ZAYO'S PRINEVILLE TO RENO PROJECT

CPUC MINOR PROJECT REFINEMENT FORM

Date Requested: 15 Oct 2024	Report No.: 7
Date Approved: 11/6/24	Approval Agency: Caltrans, in addition to CPUC
Property Owner(s): Caltrans (State Route 395 ROW)	Location/Milepost: PM M-36.08 to M-36.22 (S to N)
Land Use/Vegetative Cover: Ruderal (maintained highway shoulder near edge of pavement)	Sensitive Resources: Waterways at culverts to be avoided by boring underneath culverts. Cultural resources will still need to be avoided. (See project webmap.)

RFI No. 207-208

VIEWPORT - 27

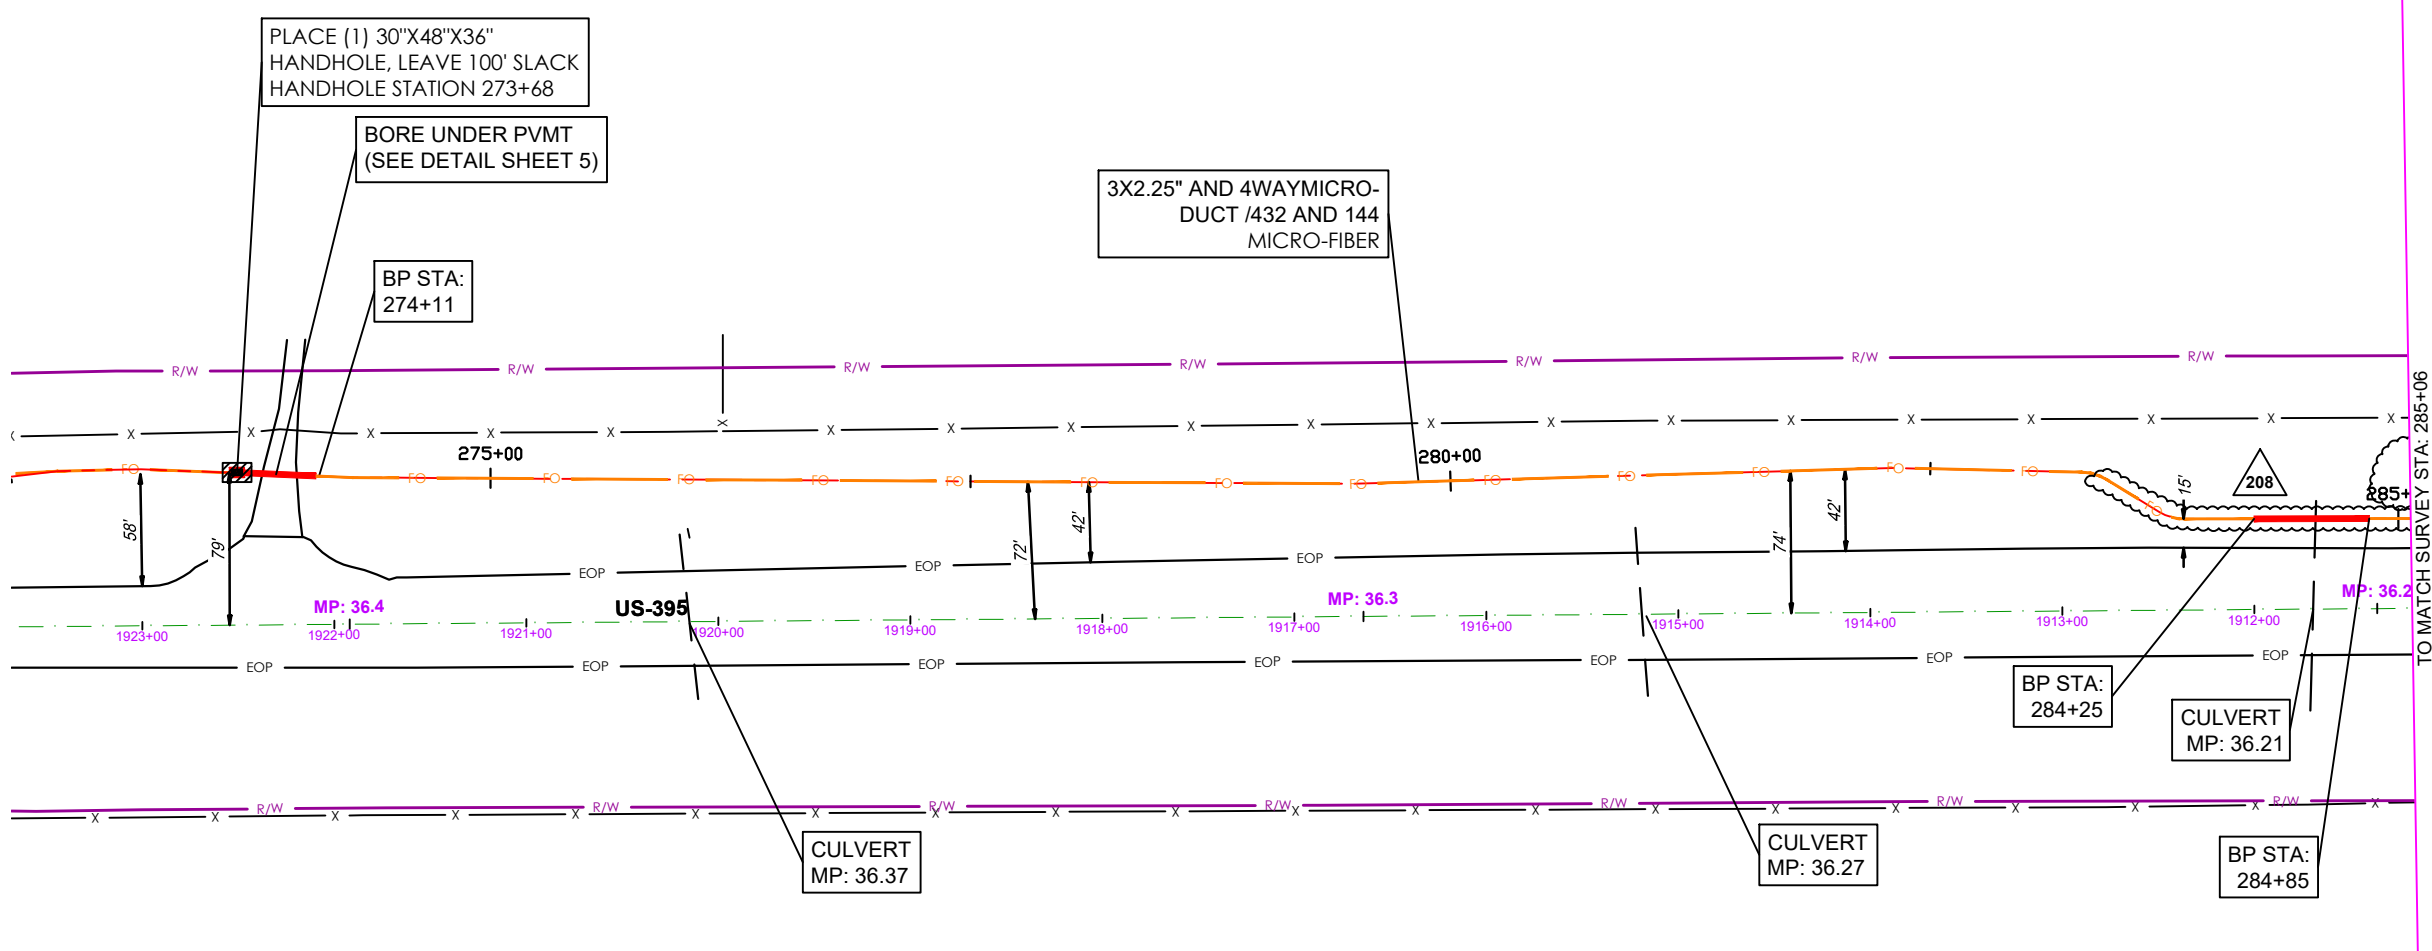
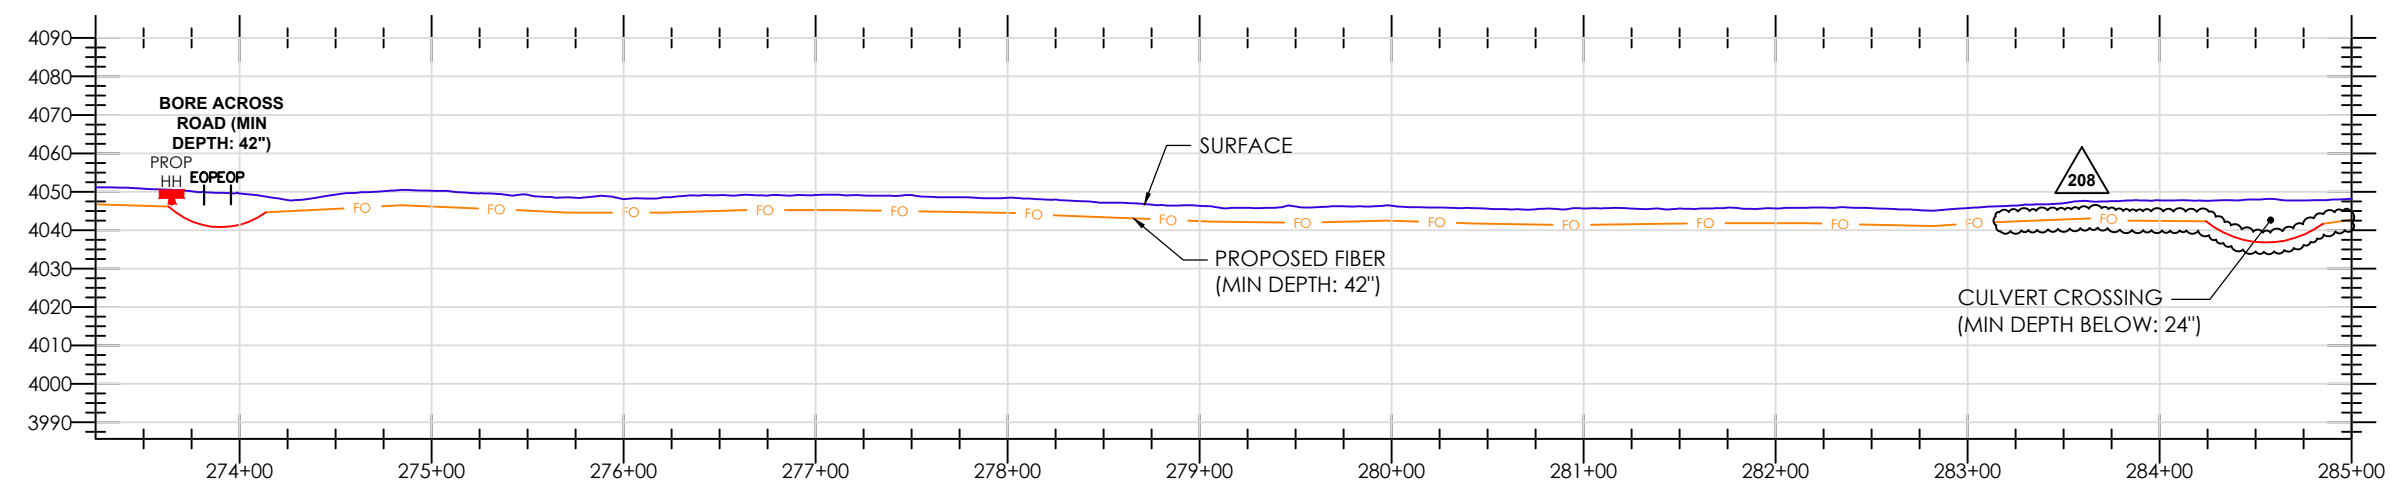
RFI NO. 0208
SHIFT ALIGNMENT 15' OFF EOP
BORE CULVERT AT MP 36.21
STA 283+75 TO STA 287+75

VIEWPORT - 28

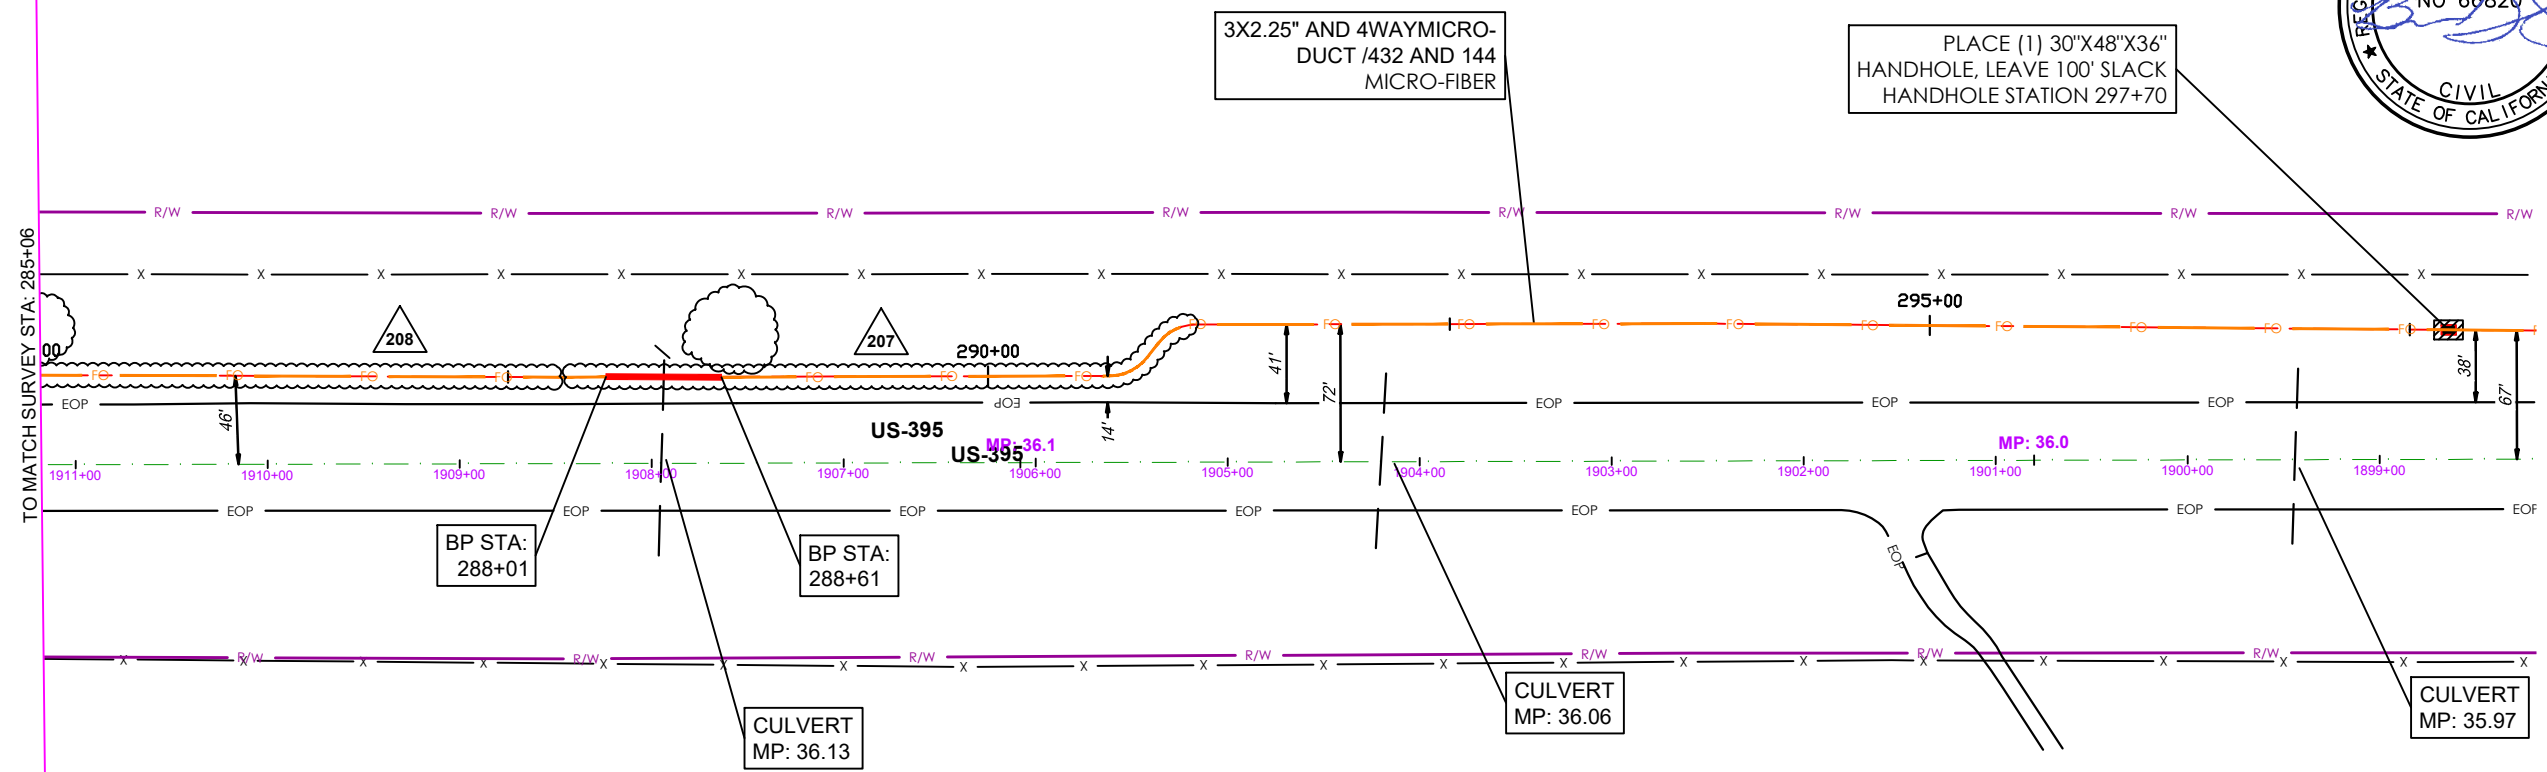
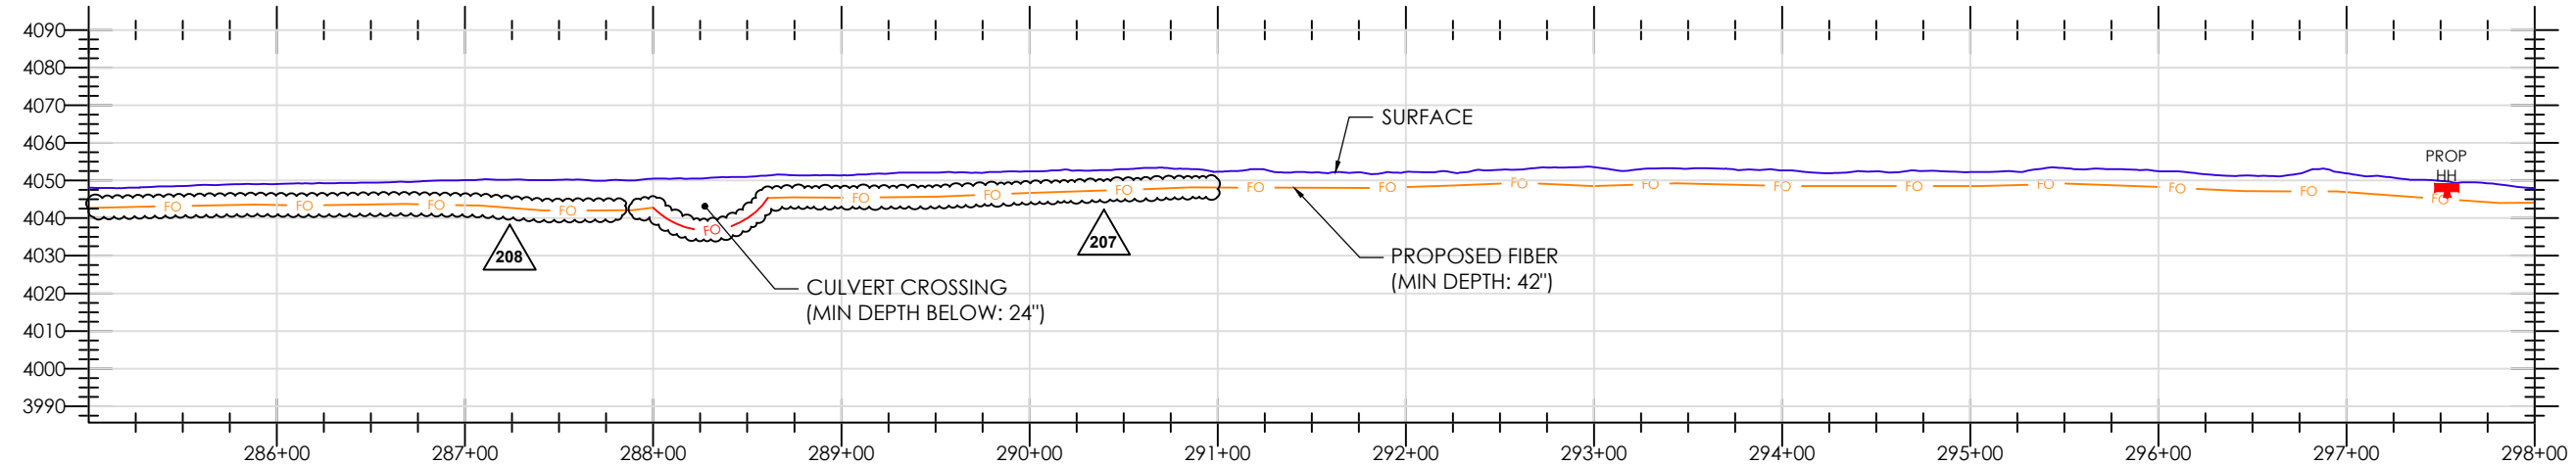
RFI NO. 0208
SHIFT ALIGNMENT 15' OFF EOP BORE CULVERT AT MP 36.21 STA 283+75 TO STA 287+75 09/30/2024

RFI NO. 0207
SHIFT ALIGNMENT 14' OFF EOP BORE CULVERT AT MP 36.13 STA 287+75 TO STA 290+90 09/30/2024
